POWER FAILURE STRATEGY

POWER FAIL CONTROLLER

FOR PR-2 Rev 1
2/97 APR

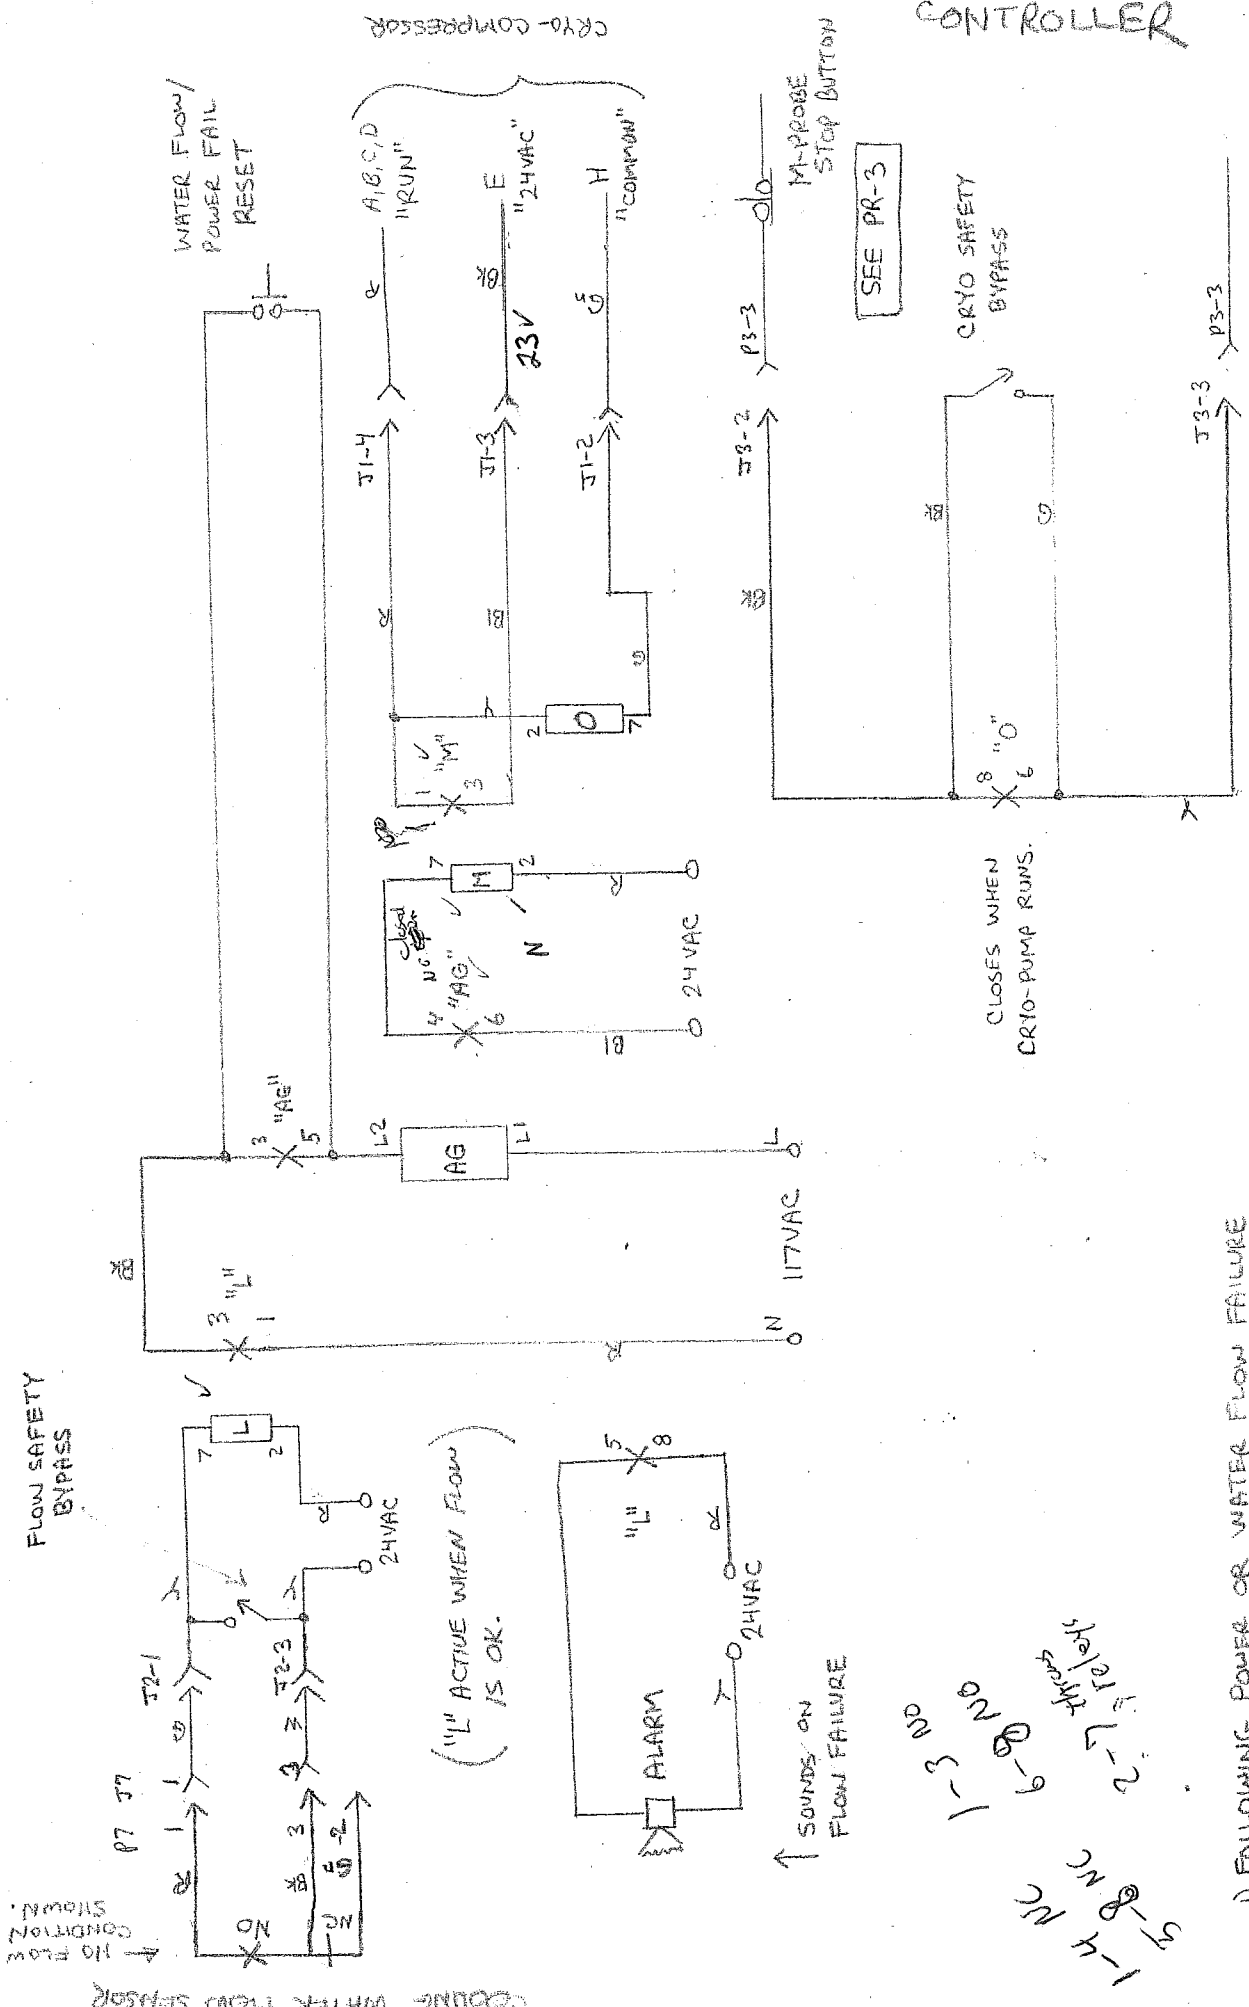
PR-2 CIRCUITS TAKE THE FOLLOWING ACTION:

3 COOLING WATER FLOW FAILURE:

~~RELEASES~~ IN 15 SECS "AG" RELEASES AND
THE CRYO COMPRESSOR ~~IS~~ IS SHUT OFF.

WHEN THE CRYO-COMPRESSOR SHUTS OFF
THE M-PROBE STOP BUTTON IS PUSHED SHUTTING DOWN
ALL ELECTRONICS & PUMPS INCLUDING TURBO & MECH.

- 1) FOLLOWING POWER OR WATER FLOW FAILURE
- CONTACTS "AG" OPEN AFTER ADJUSTABLE (15 SEC) TIME DELAY.
- 2) RELAYS L, M, O, P ARE 24VAC
- 3) J1 - 4 PIN XLR male
J2 - 3 PIN XLR female
J3 - 3 PIN XLR male
J7 - 3 PIN XLR female @ FLOW SENSOR

POWER FAIL CONTROLLER

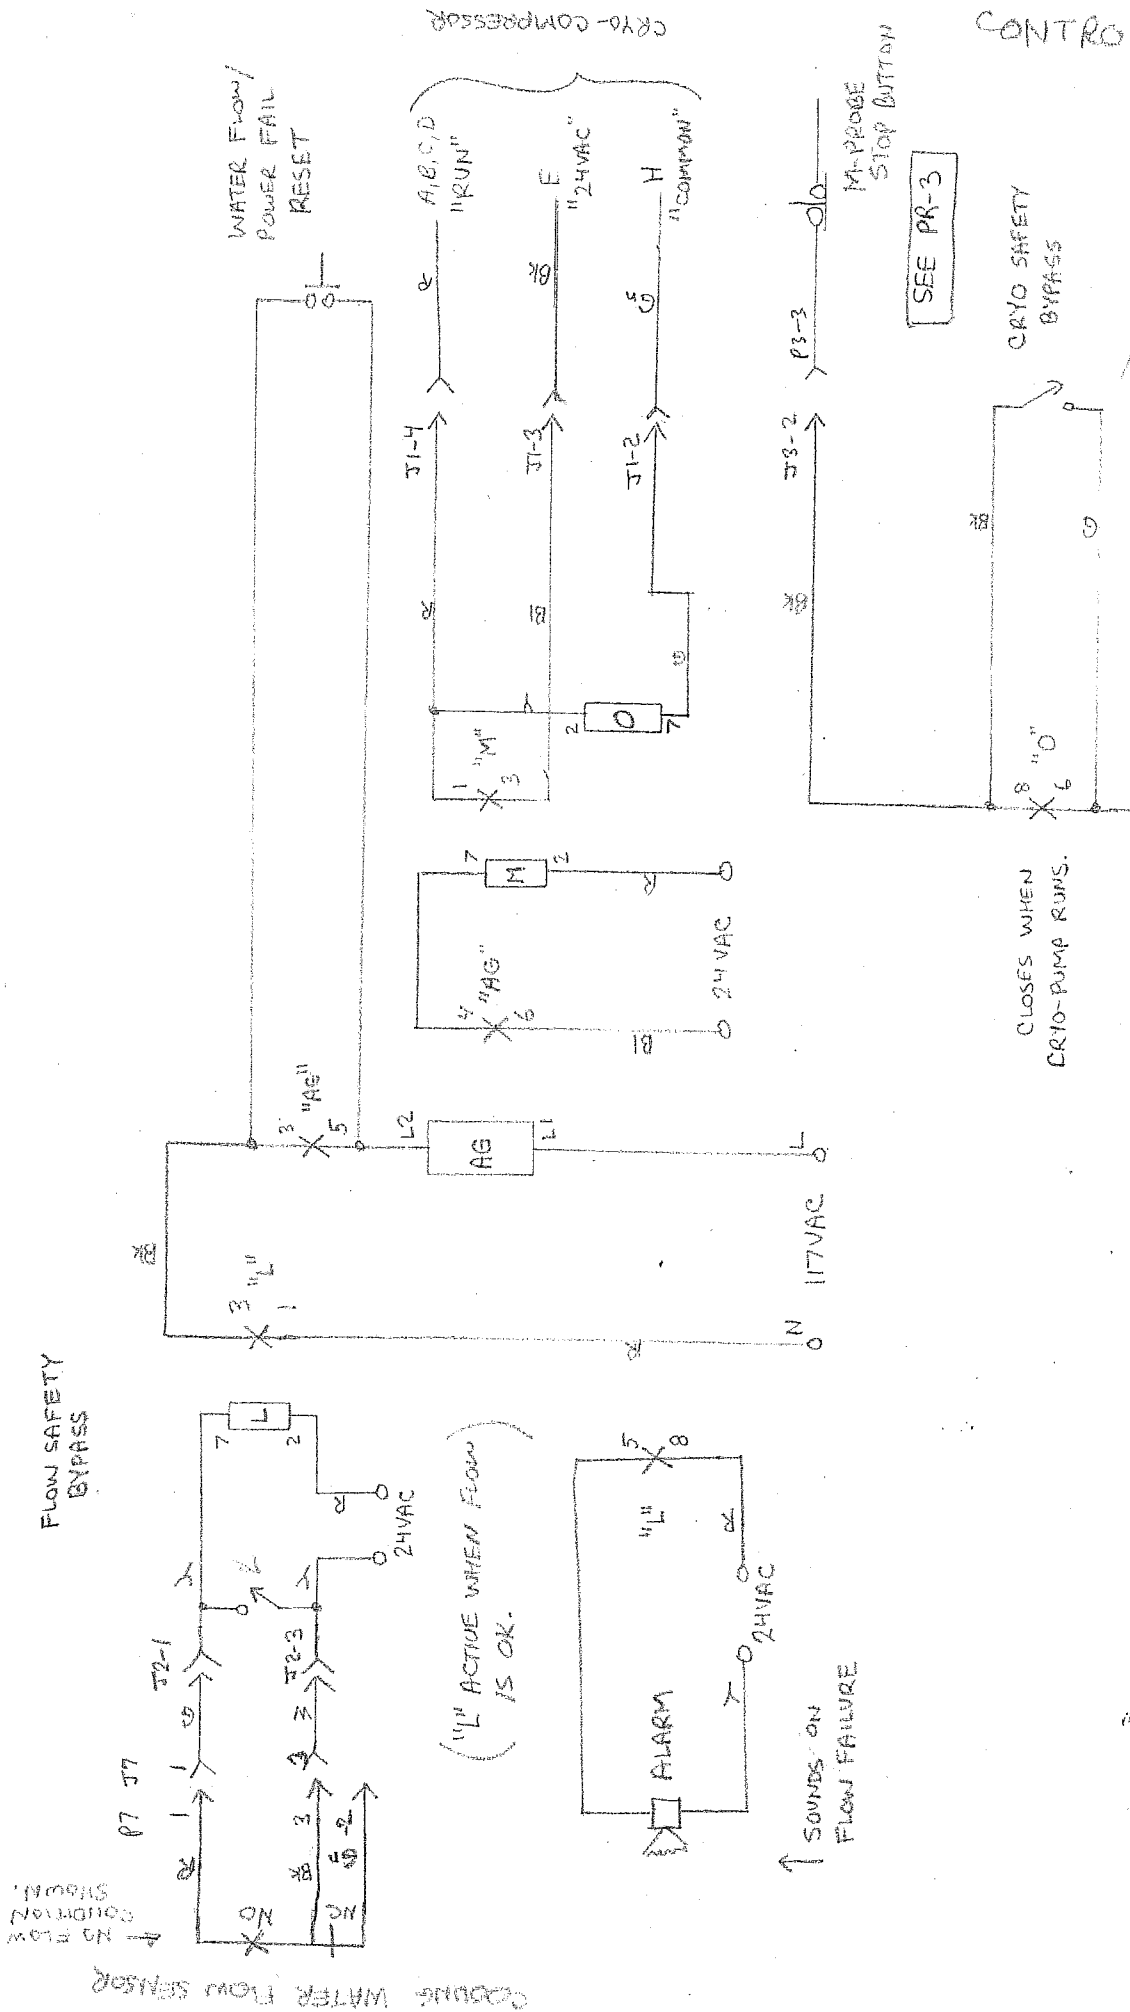
SEPARATE AC POWER FEED LENGTHEN OUTAGE TO 15 SEC DOCUMENT LABEL FRONT PANEL LOCKING SWITCHES ALARM ON ANY FAILURE F.P. LIGHTS INDICATE OK FAILURE NON-REMOVABLE POWER CORD! FAULT LATCHES ~~30 POWER FEEDBACK~~ INSTRUCTIONS

1) FOLLOWING POWER OR WATER FLOW FAILURE CONTACTS "AG" OPEN AFTER ADJUSTABLE (15 SEC) TIME DELAY.

WHEN THE PR-2 POWER FAIL CONTROLLER IS REMOVED
THE FOLLOWING JUMPERS CAN BE INSTALLED TO ALLOW
CONTINUED OPERATION (W/O SAFETY PROTECTIONS).

P2 - NO CONNECTIONS NECESSARY { WATER FLOW SENSOR

STOP BUTTON
(3 PIN XLR MALE)

CRYO COMPRESSOR
(4 PIN XLR MALE)
